To: Phil Tripp
From: Jeff Walton, Associate Planner; 910-341-3260
CC: File;
Date: 5/10/2023
Re: Forest Park Townhomes

The following is a list of comments for review from planning regarding the project. Please provide your corrections as listed below. A staff summary of comments:

Jeff Walton- Planning – Attached

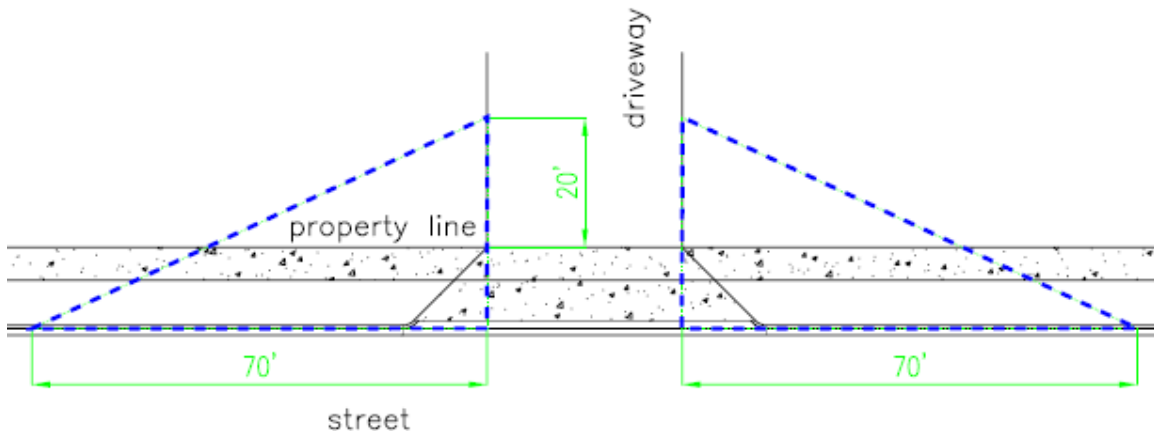
- Payment in lieu for mitigation trees:
 - $217 * 175 = \$37,975.00$
